DESCRIPTIVE REPORT

Field No. LISP-1250 Office No. H-7842

Locality HEMPSTEAD BAY-REYNOLDS CHANNEL

REVIEW OF HYDROGRAPHIC SURVEY

Location of Proposed Area to be Dredged in Hewlett Bay,
Town of Hempstead, Nassau County, New York.

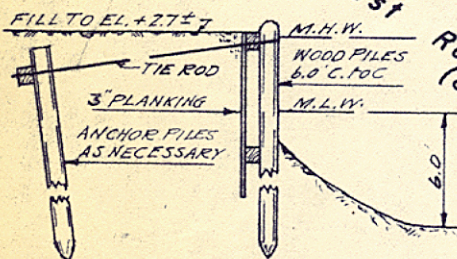
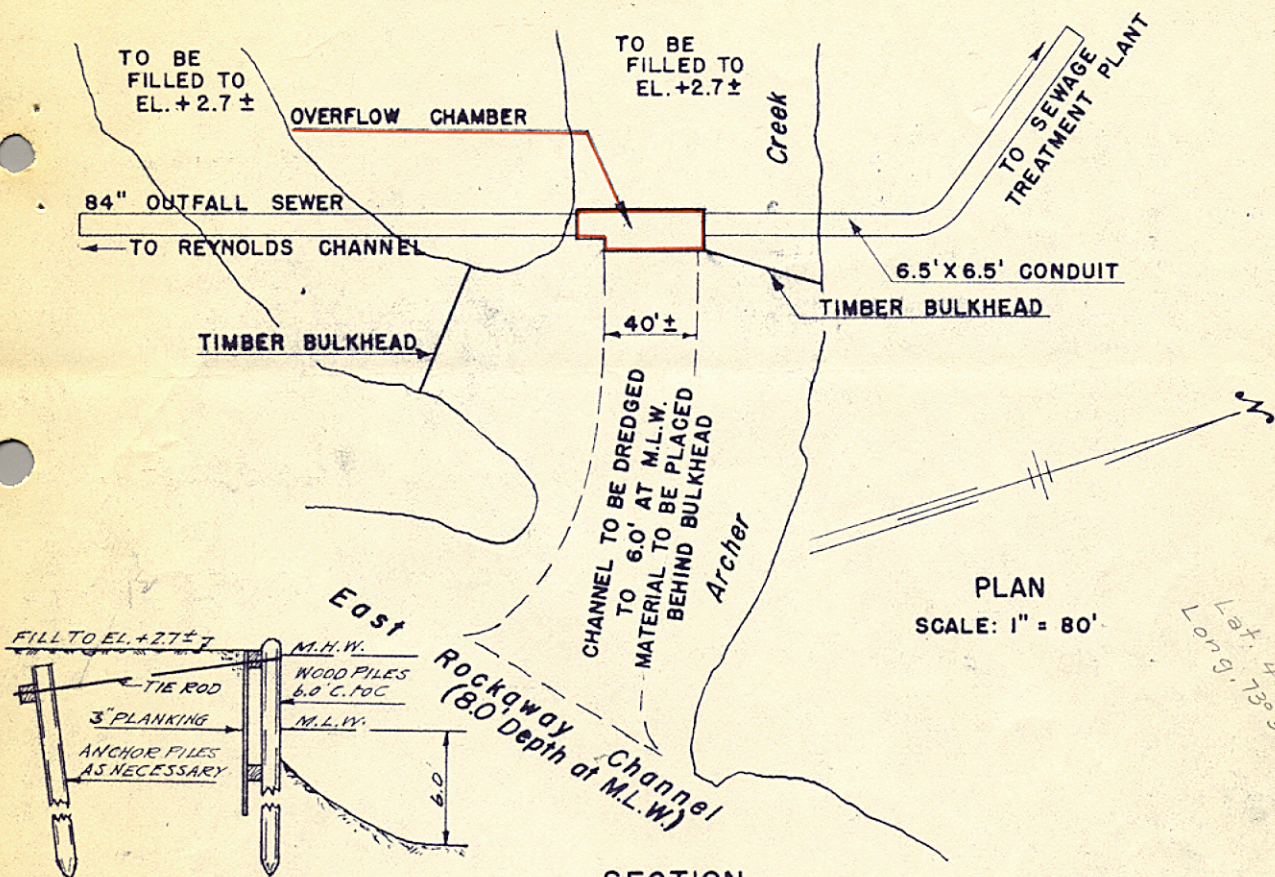
*Dredging in Hewlett Bay had been
completed prior to the hydrographic
survey of 1950*
